STAFF REPORT

SPECIAL EXCEPTION AMENDMENT

APPLICATION SEA 01-M-036-02

APPLICANT:	Pinecrest School, Inc.
ZONING:	R-4
PARCEL(S):	60-3 ((14)) – 2B
AREA:	2.00 acres
SPECIAL EXCEPTION CATEGORY:	Category 3: Quasi-Public Uses
PLAN MAP:	Public Facilities and Institutional
PROPOSAL:	To increase maximum enrollment of a private school from 120 to 180 students; increase grade level; add pre-and after-care; modify hours; and replace one school building; plus related site and development condition modifications.

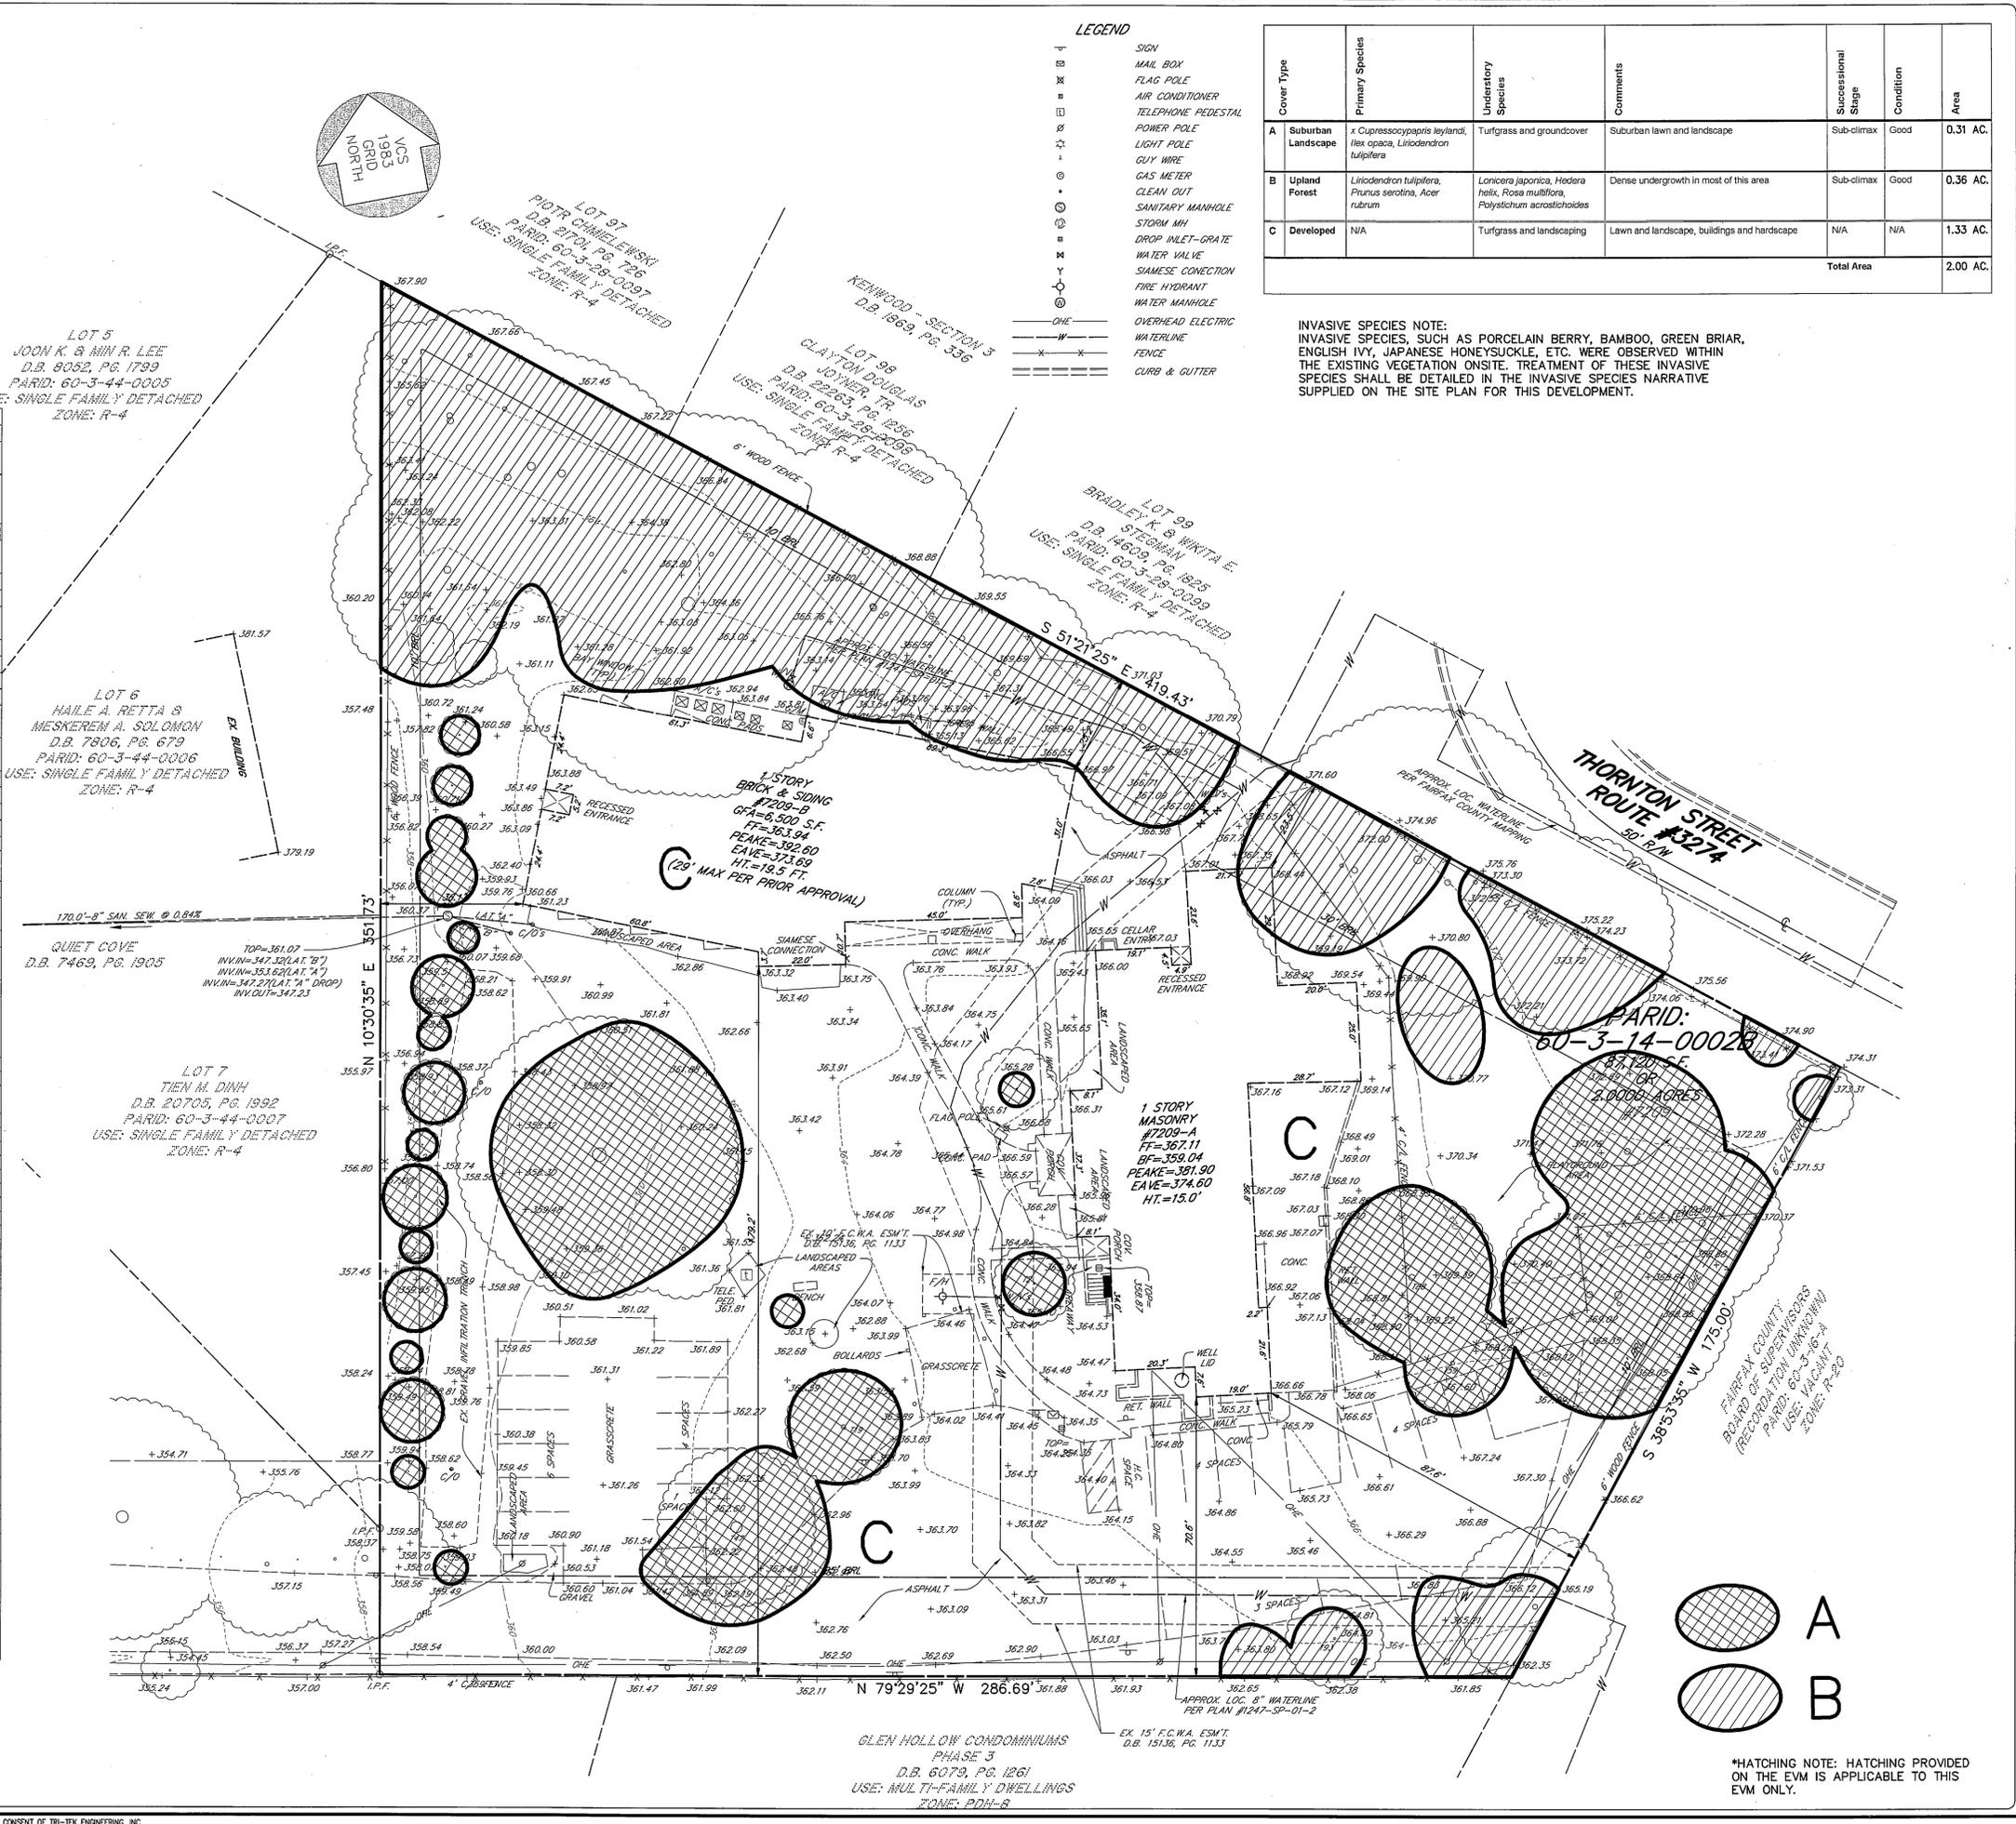
According to the table provided on Sheet 5 of the SE Plat, the proposal would achieve 29,915 square feet of canopy coverage, 21,515 square feet of which (72 percent) would be achieved through tree preservation, which would appear to exceed the tree cover and tree preservation requirements for the site.

Figure 8: Proposed parking layout (highlighting by staff).

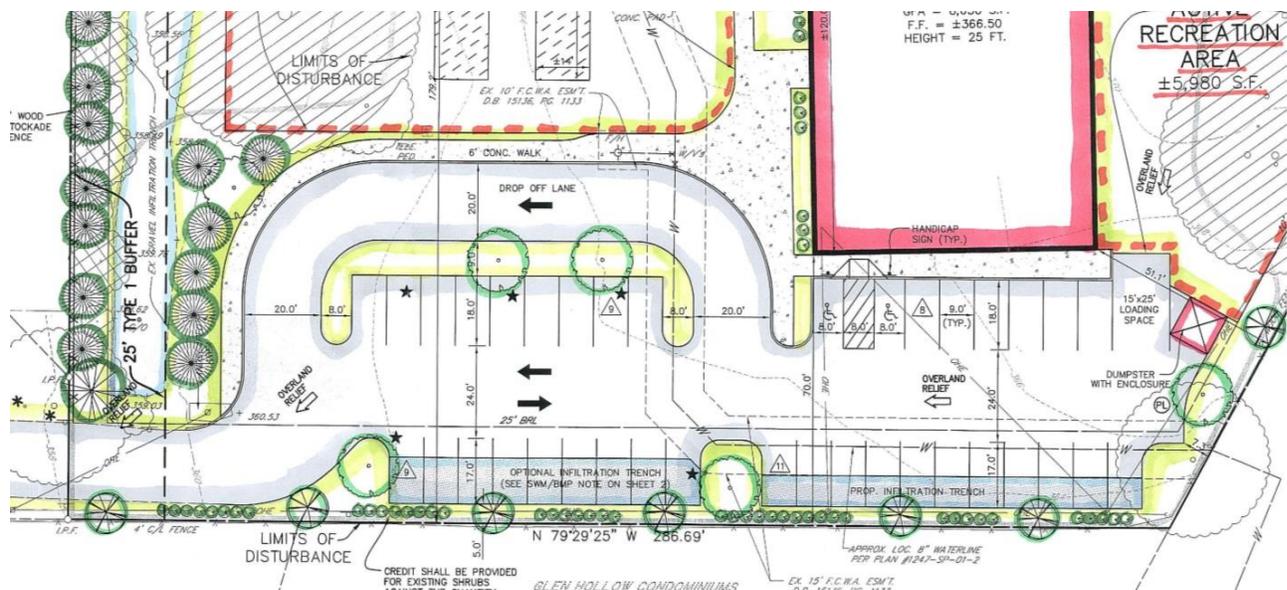
To accommodate the proposed increase in student enrollment and number of staff, additional parking would be provided by reconfiguring the parking areas to include 37 parking spaces, and a dedicated drop off/pick-up lane to improve vehicular circulation on the site.

Figure 9: Proposed recreation areas (highlighting by staff).

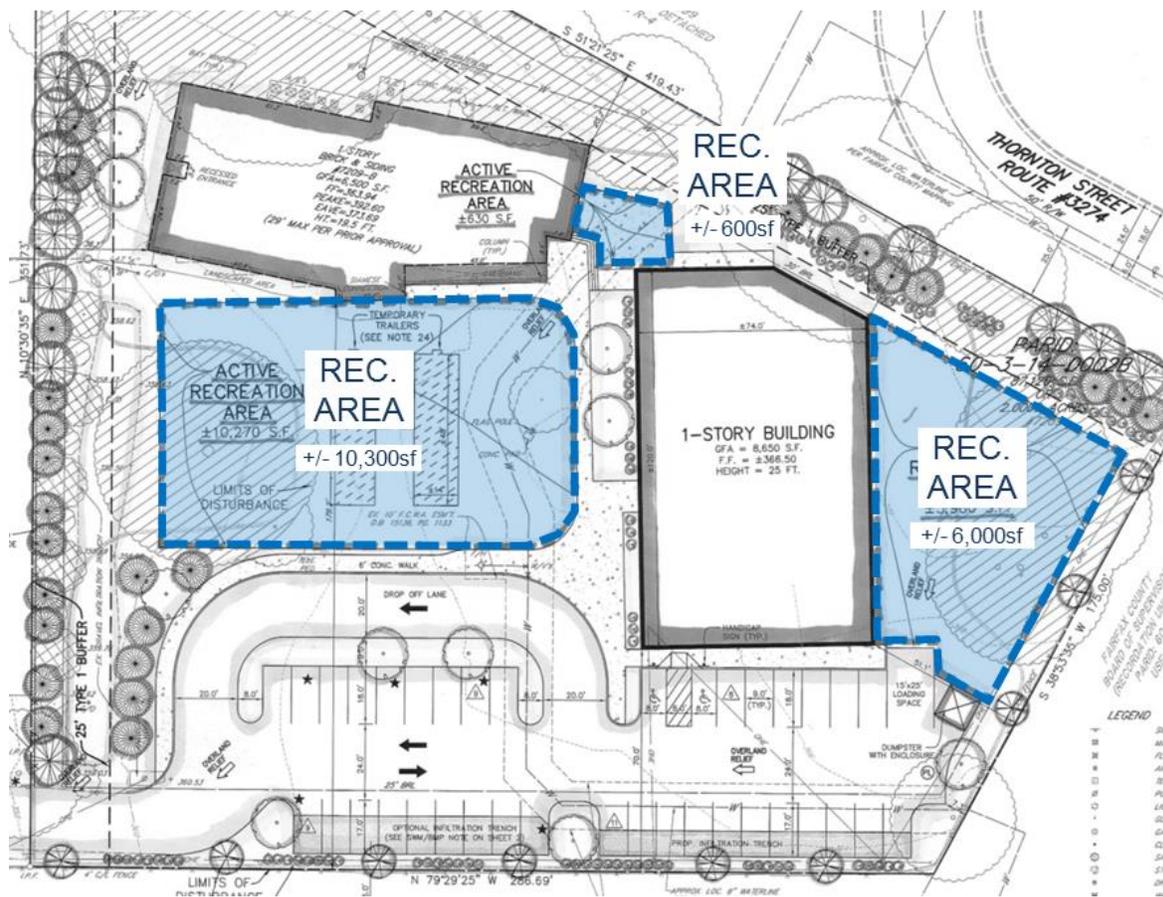
A total of 16,880 square feet of outdoor recreation areas are delineated on the SEA Plat, including a 5,980-square-foot area to the east of the proposed building (an area that is currently a fenced playground), 10,270 square feet of lawn area in the center of the lot, and a small, 630-square-foot, paved “court” area between the two buildings.

Figure 1B
Future Traffic Forecasts with Pinecrest Expansion

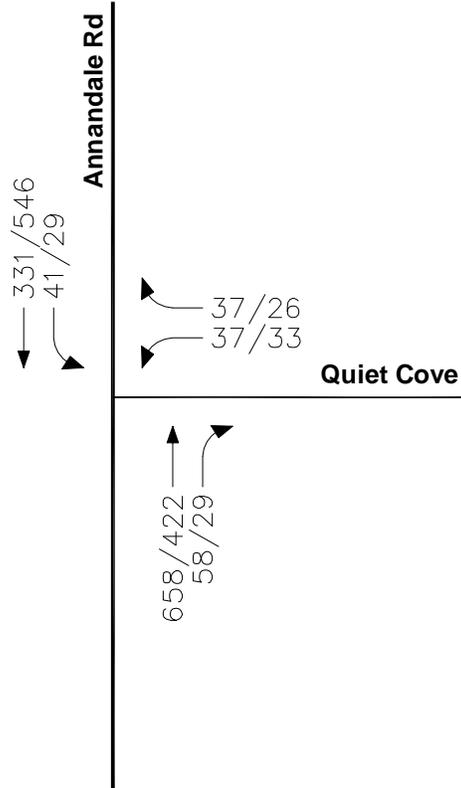
Resolution: *Upon review of the response provided, given the configuration of Annandale Road as a four-lane, undivided, roadway and the volumes reflected on Figure 1B, VDOT concurred that mainline operations would not be impacted by the volume of lefts turning into Quiet Cove with the 180 student increase and with the roadway configuration as exists today. However, both VDOT and FCDOT requested the turn lane warrants also be reviewed in terms of the current approval of 120 students in order to assess the impact of the additional 60 students.*
